MAJOR PROJECT ASSESSEMENT
University of Technology,
Broadway Building
Major Project Application MP
09_0212

Director-General's
Environmental Assessment Report
Section 75I of the *Environmental Planning
and Assessment Act, 1979*

November 2011

Figure 10: Night view from Broadway

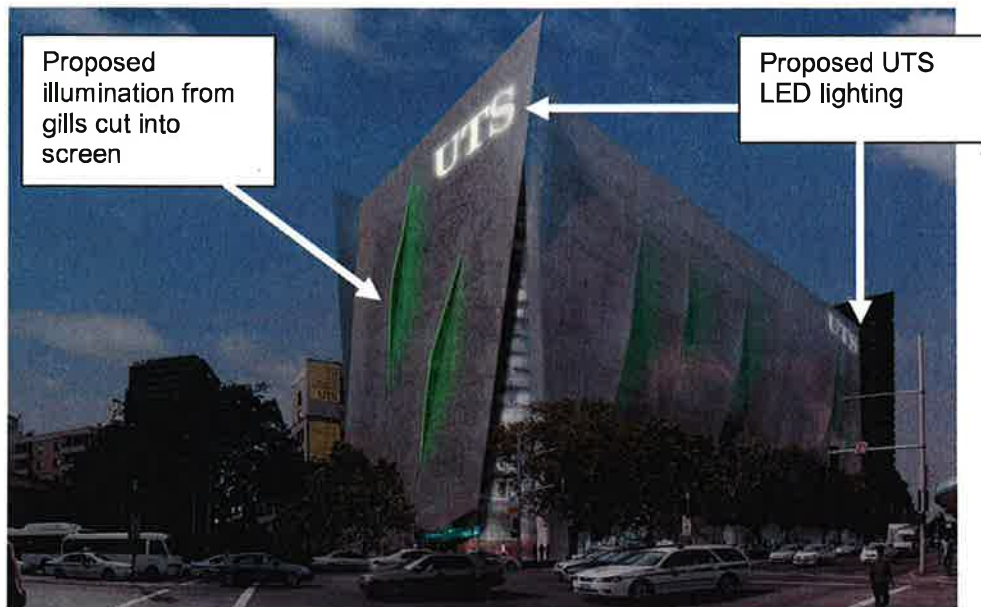
In terms of signage and illumination, the Proponent intends to have the name 'UTS' embedded into the top left corner of the Broadway and Wattle Street façades (**Figure 10**), each with a total area of 40m². The Proponent has prepared the proposed signage to comply with the Council's Signage DCP. The proposed 'gills' will have a subtle green glow lighting at night, creating an 'activating' effect on the building.

Figure 11: Dimensions and proposed lighting of walkway along Broadway
Source: Preferred Project Report

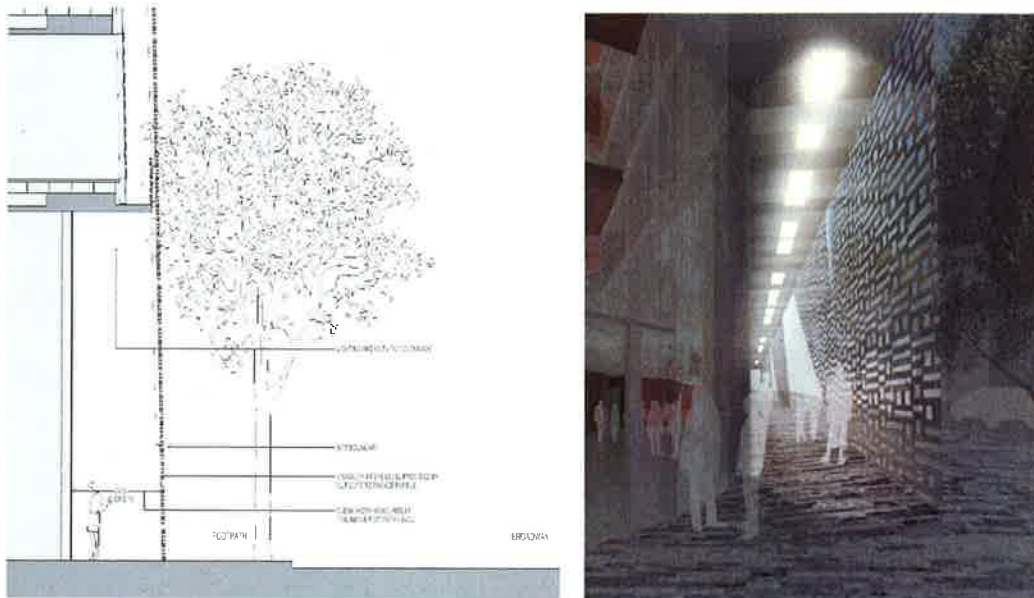
It was noted that pedestrian movement may be restricted by the screen (**Figure 11-12**) which extends to the ground. The Department believes that the 2.425 metre wide colonnade created between the screen and building is sufficient for pedestrians to move easily in this area.

The colonnade between the building and the screen will also give pedestrians protection from wind and rain along the length of the Broadway frontage, with additional protection on the Jones Street and Wattle Street frontages.

Figure 13: Landscape Plan
Source: Preferred Project Report

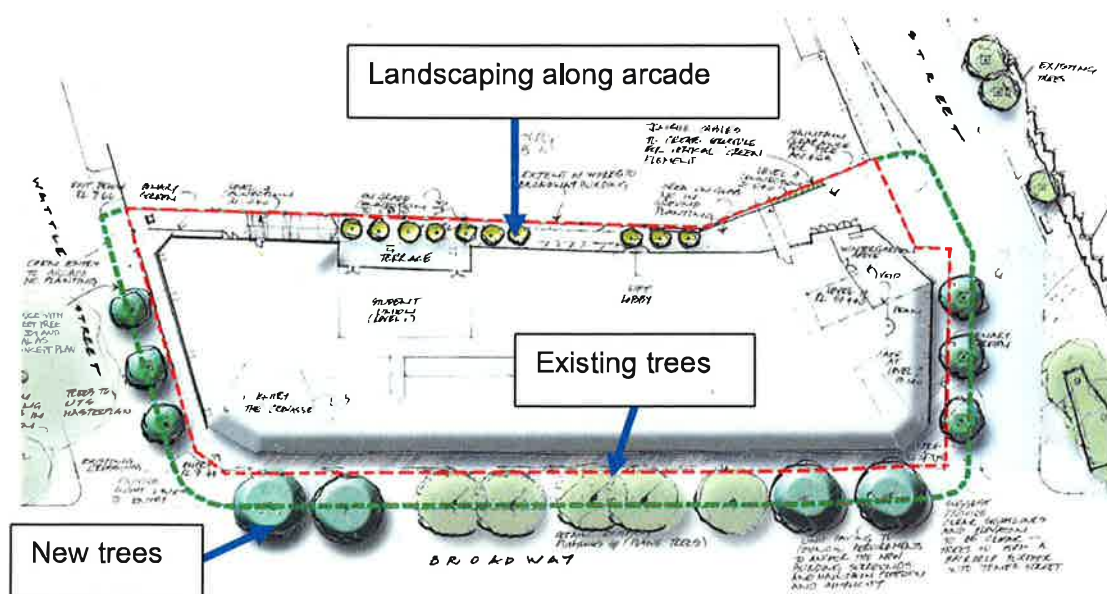
The City of Sydney requested further detail on the proposed microclimate zones, vertical elements and on how the laneway will function. Council also requested adequate setbacks of trees for their natural development along Broadway.

The Department is supportive of the proposed landscape plan (**Figure 13**) which is consistent with the approved Concept Plan. In terms of improving the public domain along Broadway, the five existing street trees along Broadway will be supported by four new trees which will be similar to the existing trees in this area.

The Department believes that the proposed design uses the limited space (width range from approximately 2.6m to 8.6m) in areas such as the arcade to the maximum benefit of its users (**Figure 14**). To this effect, the student café will flow out onto a terrace which is connected to the arcade to create useable flowing spaces.

Figure 16: Potential conflict points of the Construction Traffic Management Plan

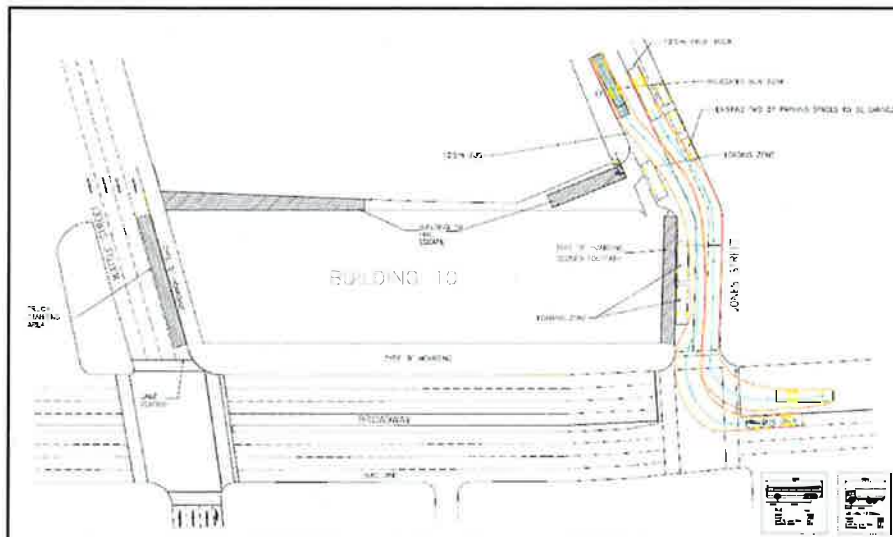
The STA argued that the proposed bus turning paths cannot be supported as conflict points were identified for buses passing moving and parked vehicles in Jones Street.

The Proponent argued that its Construction Traffic Management Plan identified all the potential conflict points and shows that all vehicles can manoeuvre safely (Figure 16).

As a result of the above arrangements, the swept paths for a bus entering Jones Street and a heavy rigid truck leaving Jones Street have been overlaid to show that they can pass each other. All of the swept paths allow for 300mm clearance of kerb and 300mm clearance to other vehicles. This will result in a 600mm clearance and allow two vehicles to pass each other.
